REVISION	DATE	DESCRIPTION	BY
1	03/11/21	ISSUE FOR \$4.56	CH/PH
2	02/12/21	ISSUE FOR \$4.56	CH/PH

- REVISION NOTES**
- DRIVEWAY AMENDED TO SUIT RFS REQUIREMENTS FOR ACCESS TO NO.16 WYATT AV.
  - COOKTOPS ADDED TO LODGER ROOMS

**NORTHERN BEACHES ESSENTIAL SERVICES ACCOMMODATION**

14 WYATT AVE, BELROSE, NSW

**DRAWING TITLE**  
 GROUND FLOOR PLAN SHEET 1  
**SCALE** STATUS NUMBER REVISION  
 1:150 @AS \$4.56 05 A 2

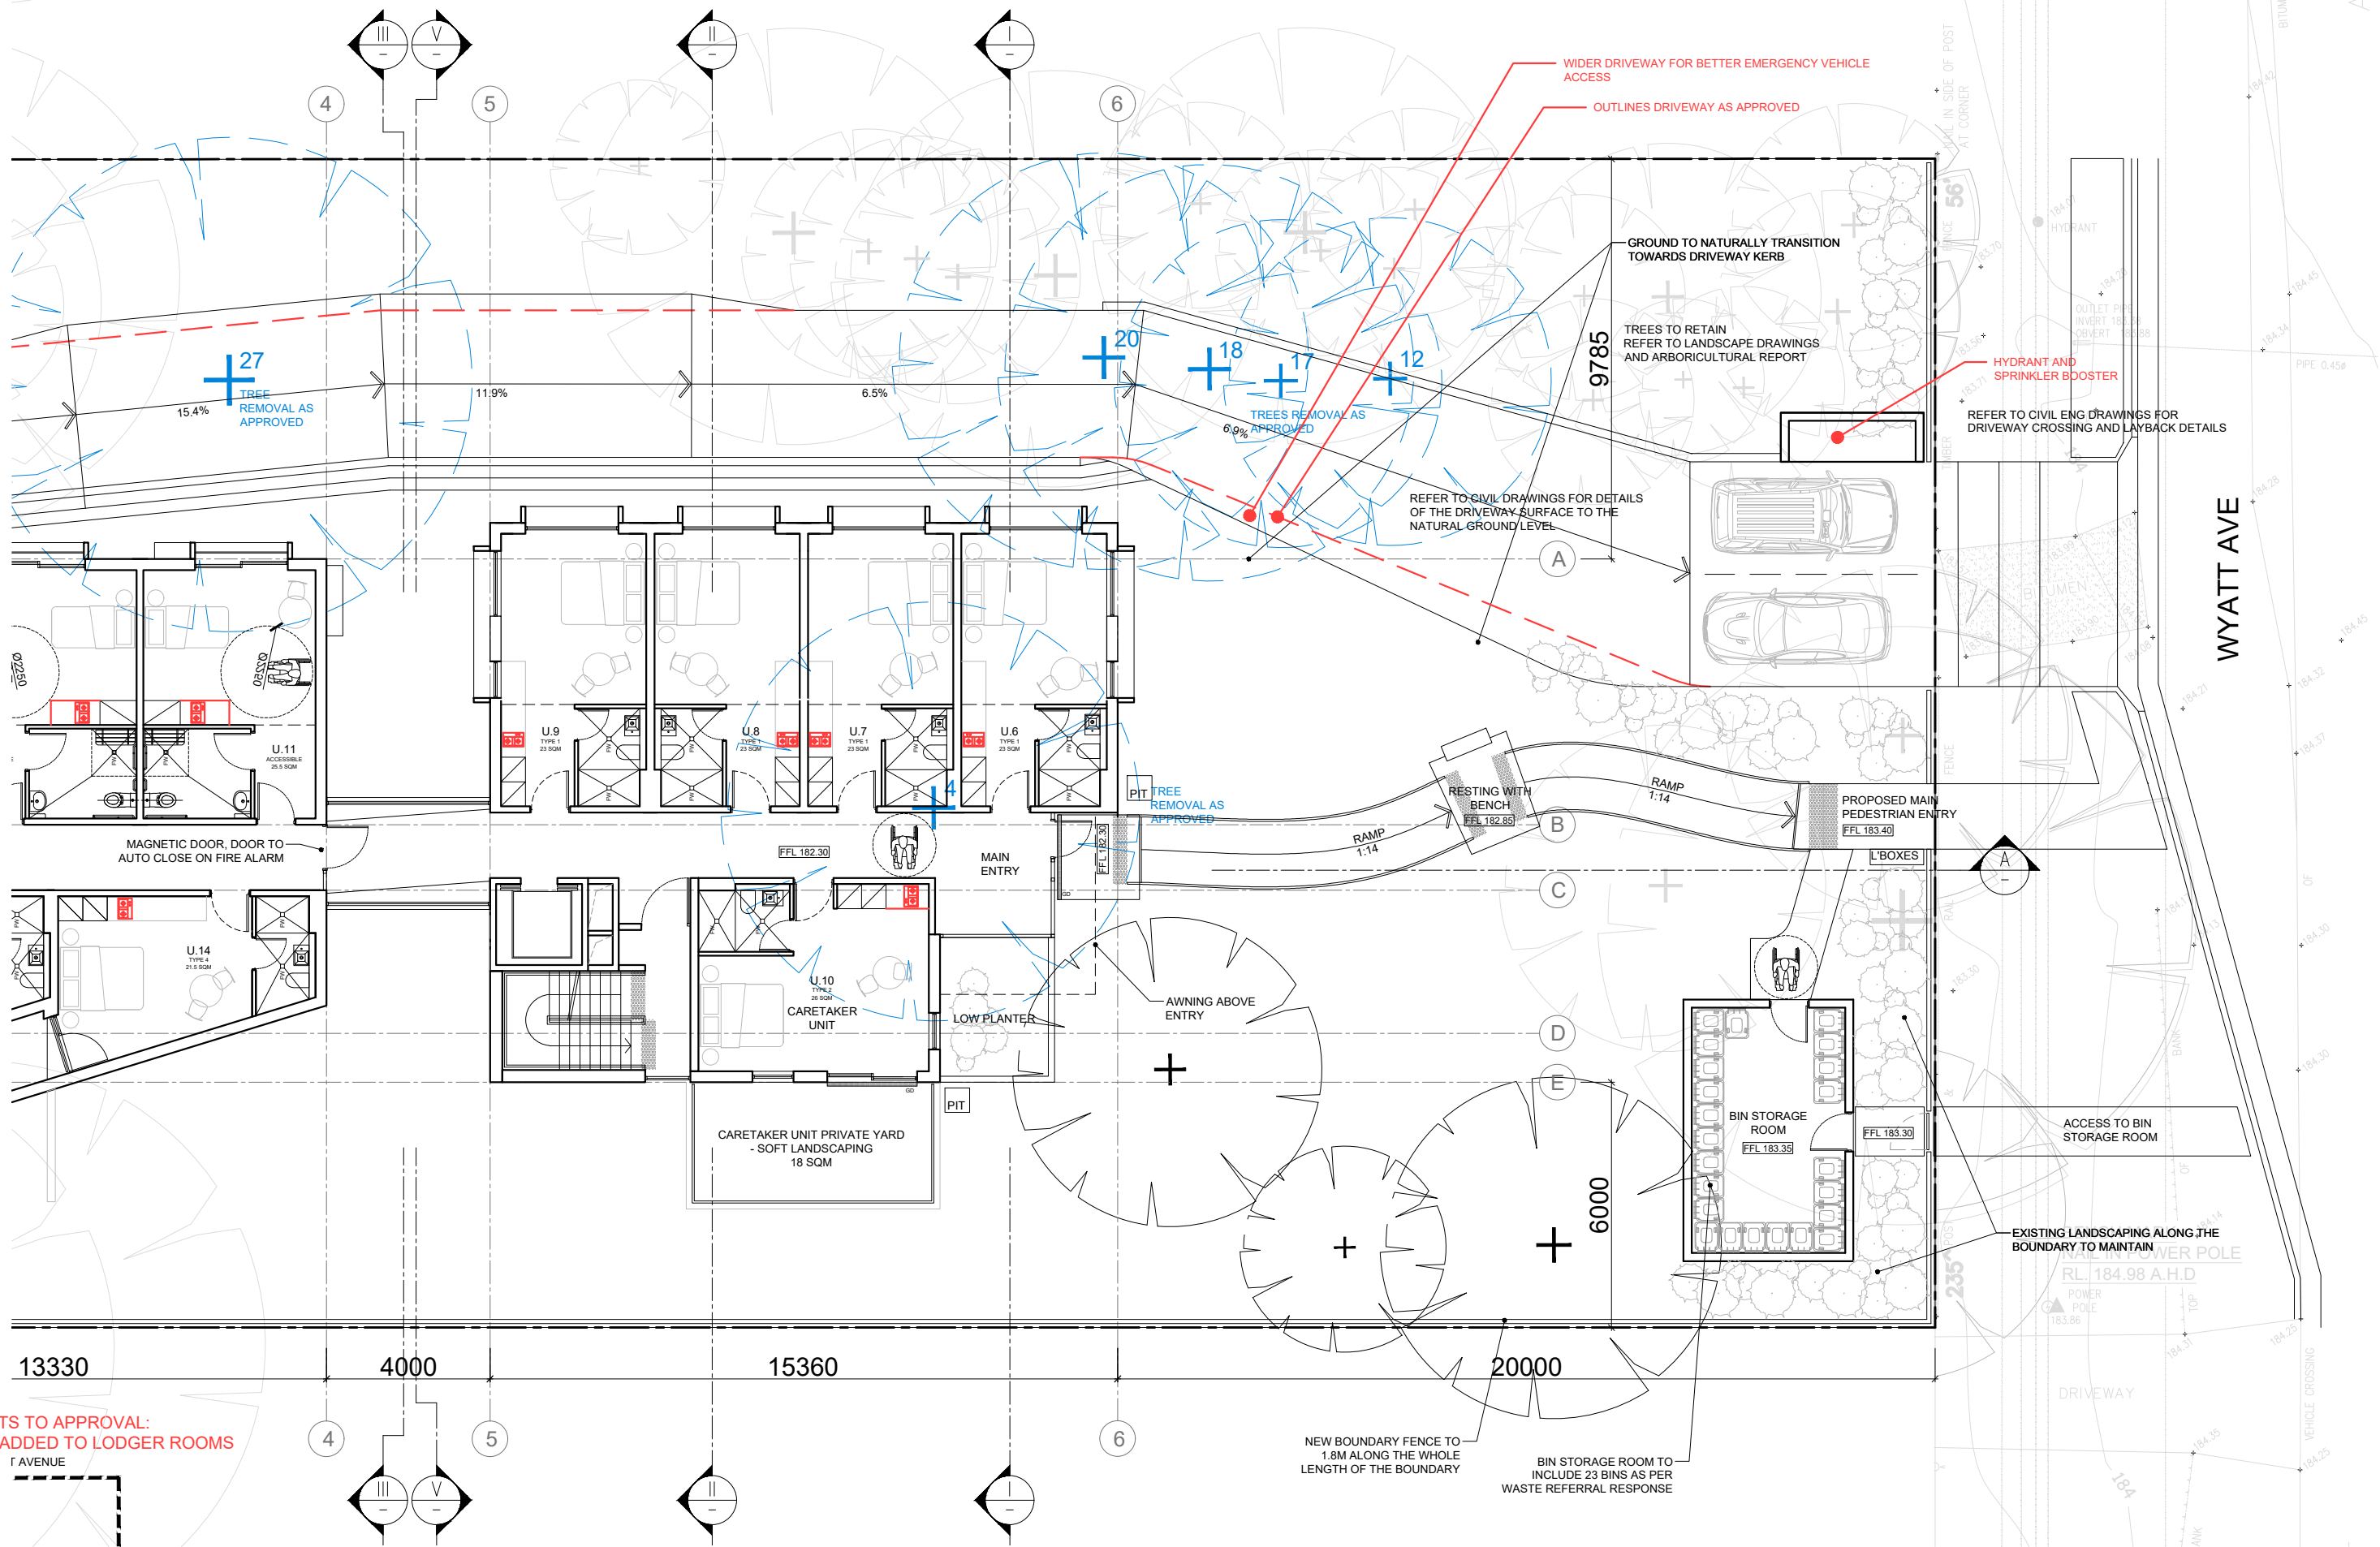
AMENDMENTS TO APPROVAL:  
COOKTOPS ADDED TO LODGER ROOMS

DRAWING TITLE  
GROUND FLOOR PLAN SHEET 2

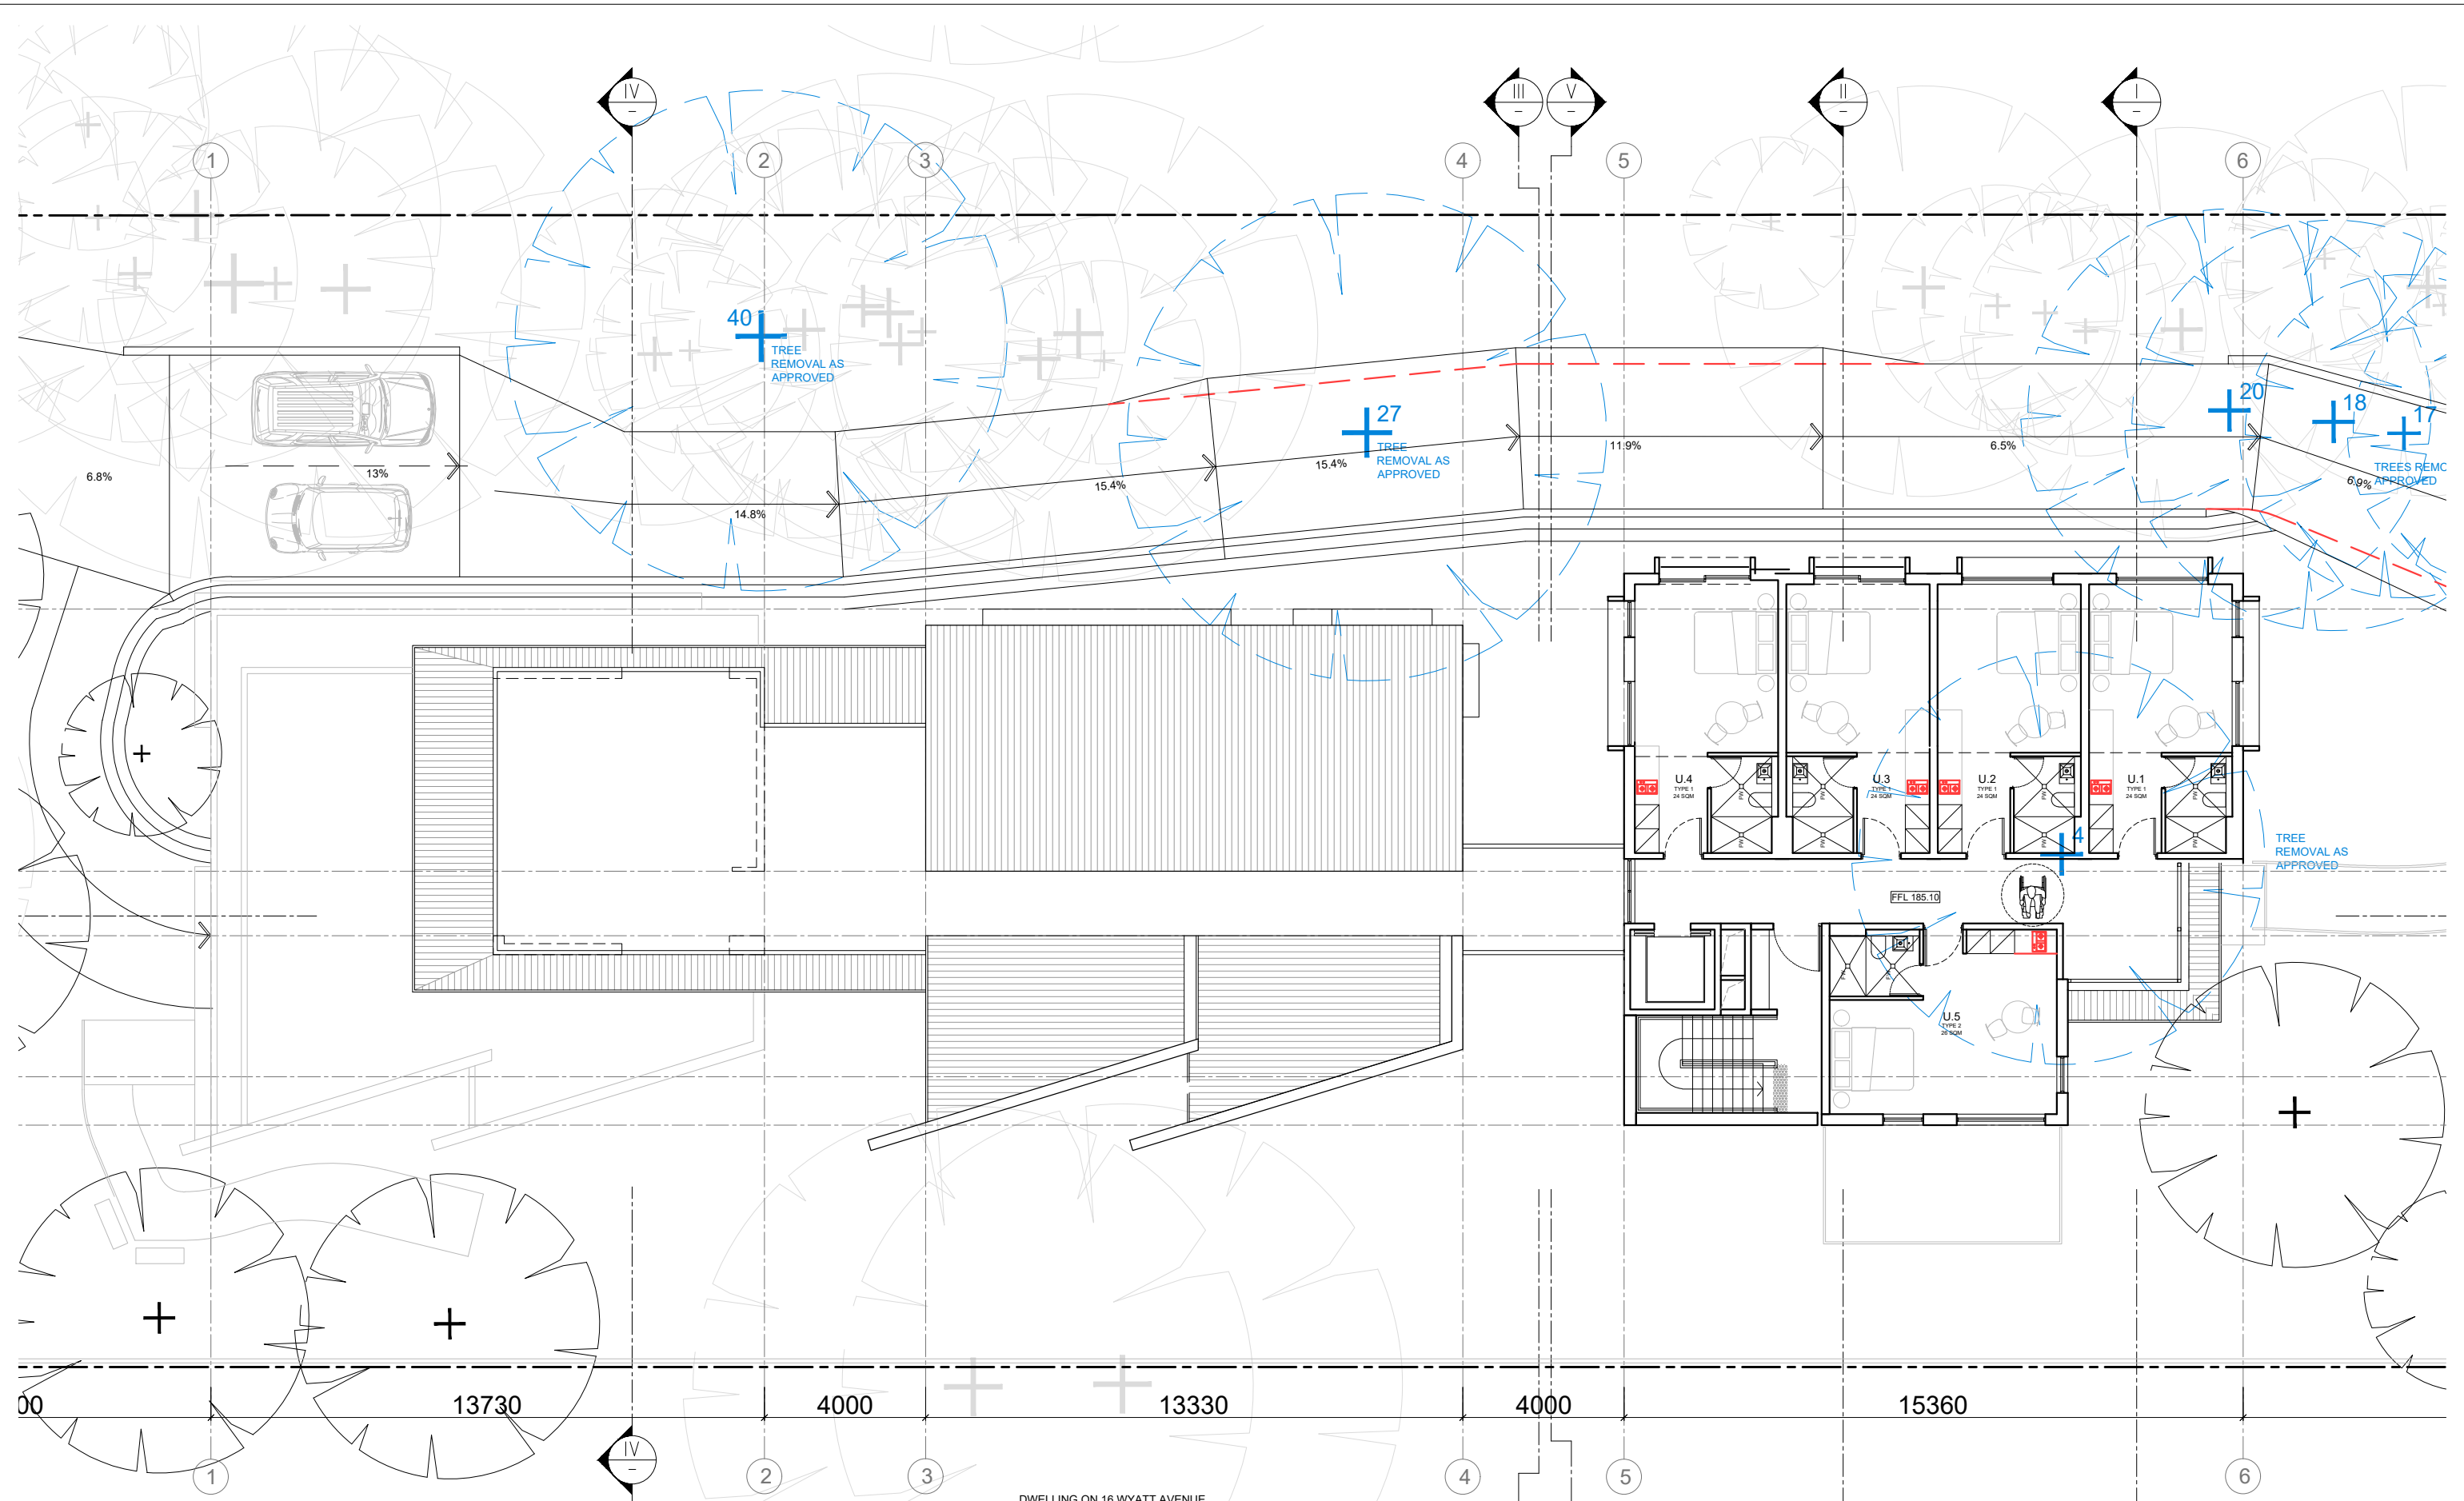
**AMENDMENTS TO APPROVAL:  
COOKTOPS ADDED TO LODGER ROOMS**
